Well Name: MUY WAYNO 18-7 FED
COM

Well Number: 402H

Sundry ID: 2868111

Type of Action: APD Change

P:\618.013 XTO Energy - NM\001 MUY Wayno 18 - Eddy\00 - MUY Wayno 18\Wells\03 - 402H\DWG\402H C-102.dwg

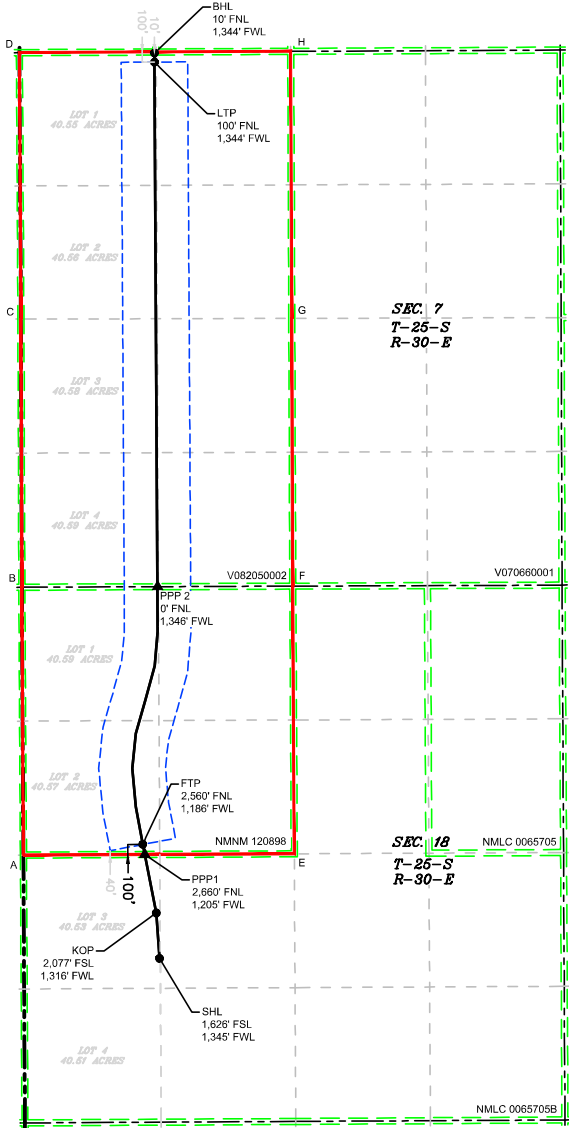
XTO Permian Operating, LLC, respectfully requests approval to make the following changes to the approved APD. Changes include SHL, KOP, FTP,LTP,BHL, proposed total depth, pool, and Dedicated Acreage.

SHL: 1436 FSL & 1345 FWL OF SECTION 18-T25S-30E 1626 FSL & 1345 FWL OF SECTION 18-T25S-30E
KOP: 2044 FSL & 684 FWL OF SECTION 18-T25S-30E 2077 FSL & 1316 FWL OF SECTION 18-T25S-30E
FTP: 2560 FNL & 685 FWL OF SECTION 18-T25S-R30E 2560 FNL & 1186 FWL OF SECTION 18-T25E-30E
LTP: 100 FNL & 685 FWL OF SECTION 7-T25S-R30E 100 FNL & 1344 FWL OF SECTION 7-T25S-R30E
BHL: 10 FNL & 685 FWL OF SECTION 7-T25S-R30E 10 FNL & 1344 FWL OF SECTION 7-T25S-R30E

Site: Muy Wayno
Well: Muy Wayno 18-7 Fed Com 402H
Wellbore: OH
Design: Plan 0

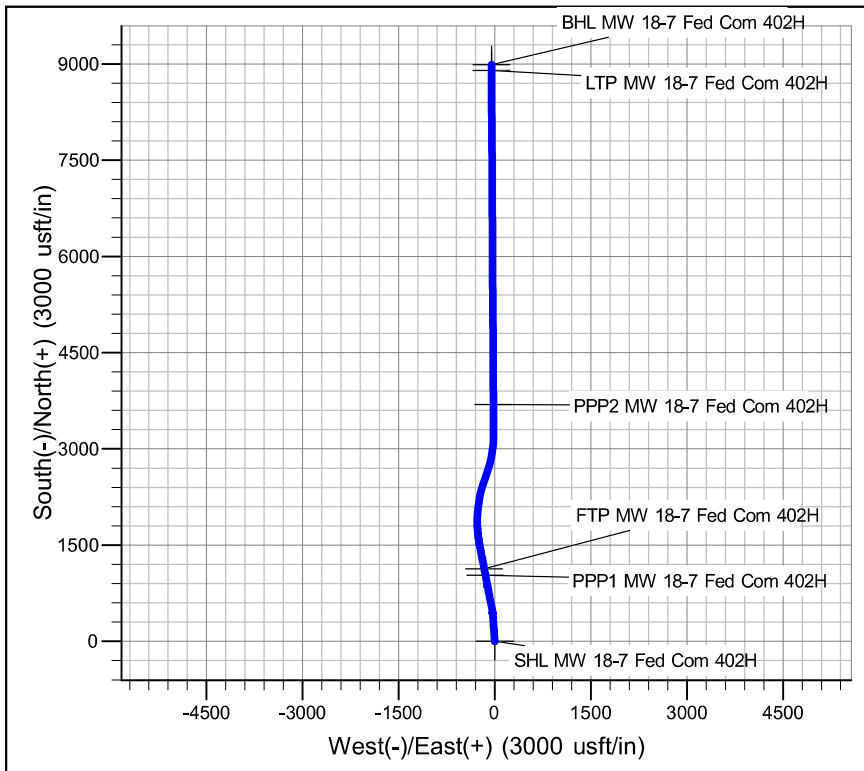
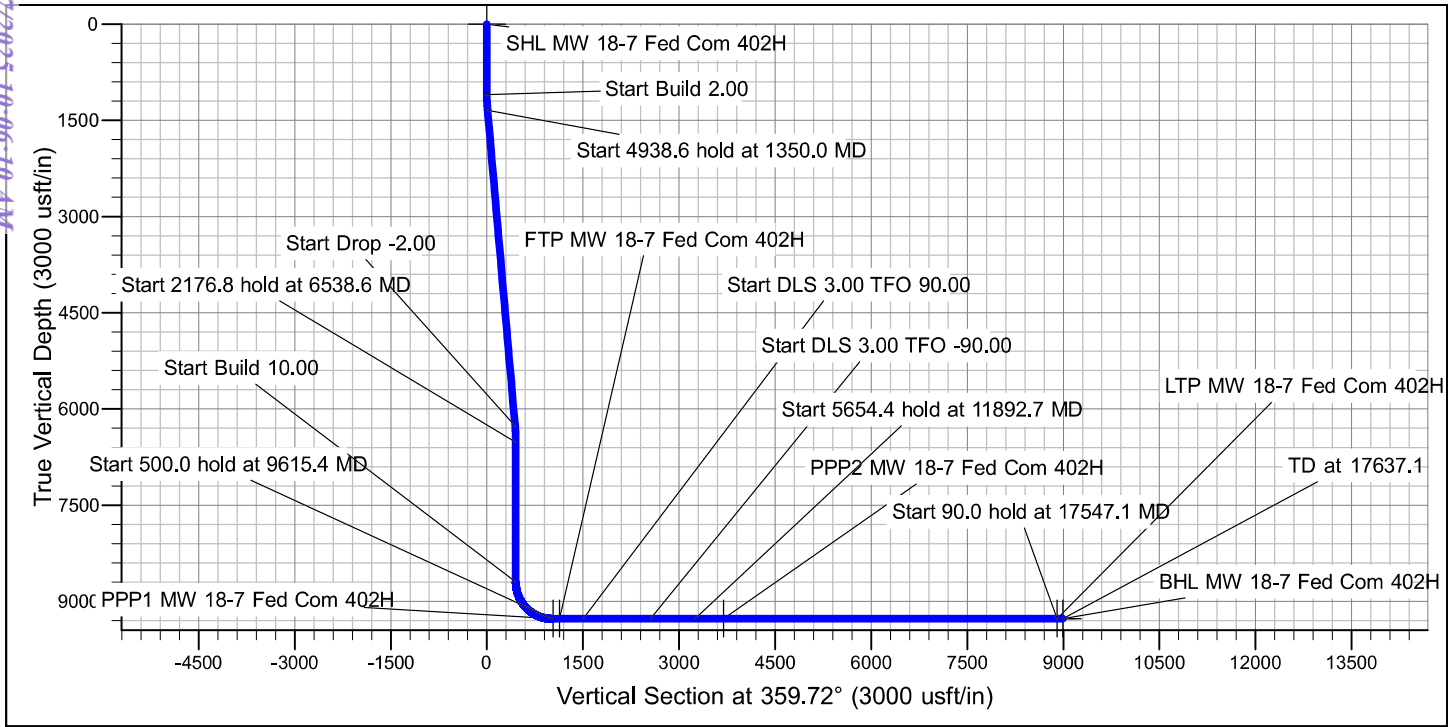
The proposed total depth is changing FROM: 18135 MD; 9776 TVD TO: 17637 MD; 9269 TVD.

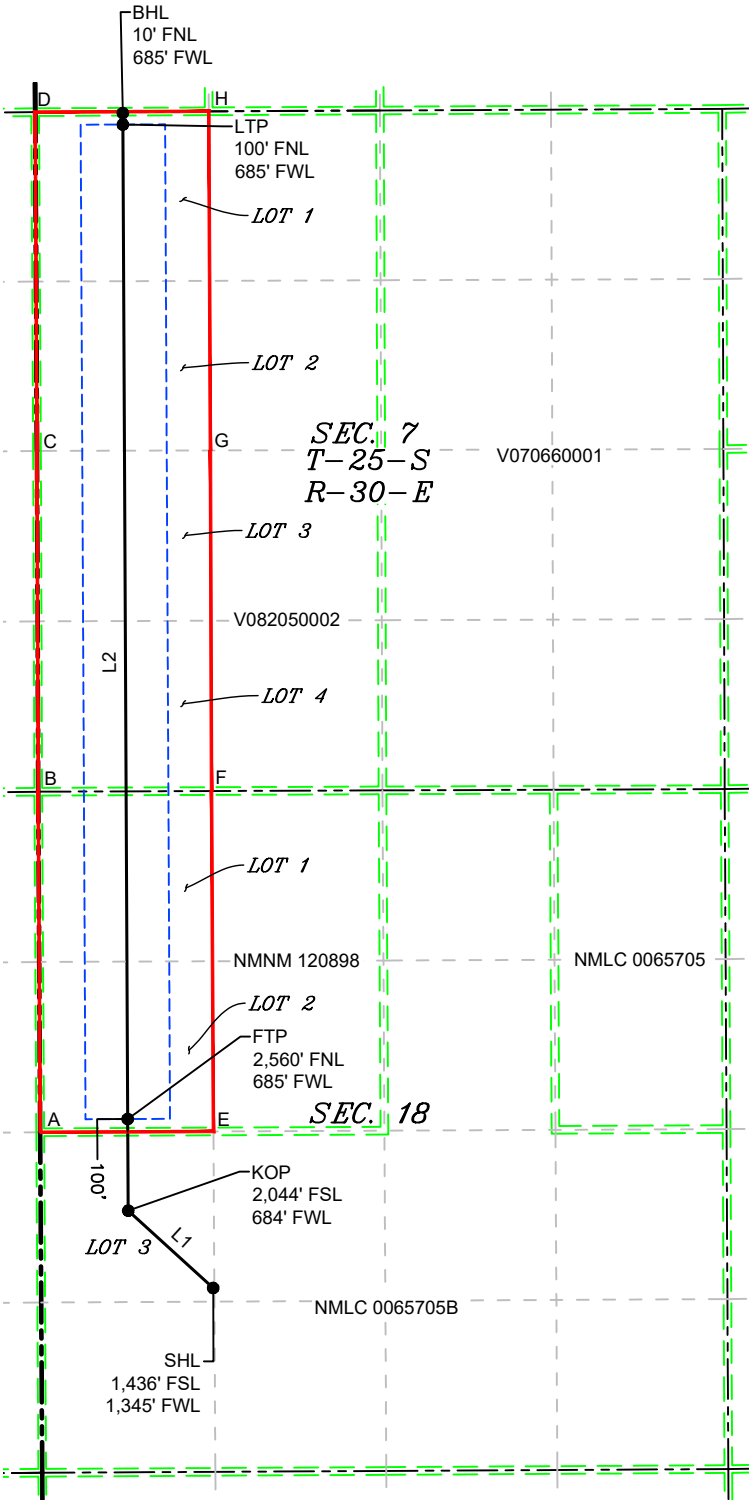
XTO Permian Operating, LLC. respectfully requests approval to change the name of this well from "MUY WAYNO 18 FEDERAL 402H" to "MUY WAYNO 18-7 FED COM 402H".
